Service Bulletin

Bulletin No.: PIP4844C

Subject: TAC Part Restriction - Accessory DC Power Control Module (APM)

Models: 2011-2013 Chevrolet Volt

3256768

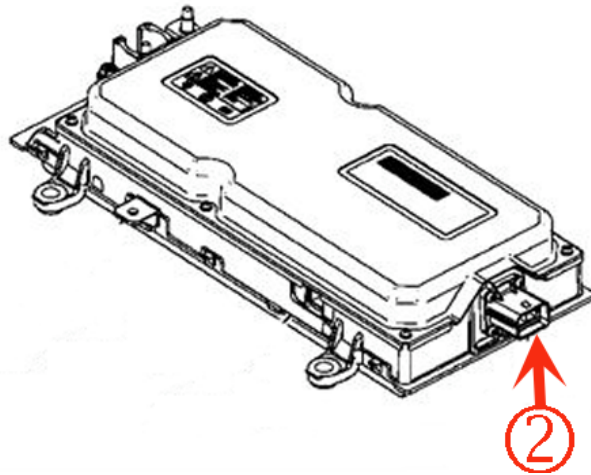
Note: There were previously two module designs available. If your vehicle has a first design module, an additional jumper harness will need to be installed. An instruction sheet will be provided with the jumper harness kit part number 24268507 on how to install the new design module. If the jumper harness instructions were not included with the new part, please contact the Technical Assistance Center for a copy of the instruction sheet. Please review the following and identify which design module is in your vehicle to see if the jumper harness 24268507 is needed.

The first design has a 24 inch orange pigtail attached to the module and there is no high voltage connection right at the module itself (See Photo Below)

All model year 2011-2012 vehicles are first design and will need the additional jumper harness to complete the replacement when using module part number: 24262768.

All 2013 model year vehicles built before VIN break: 1G1RA6E46DU120394 are first design and will require the additional jumper harness to complete the replacement using module part number: 24262768.
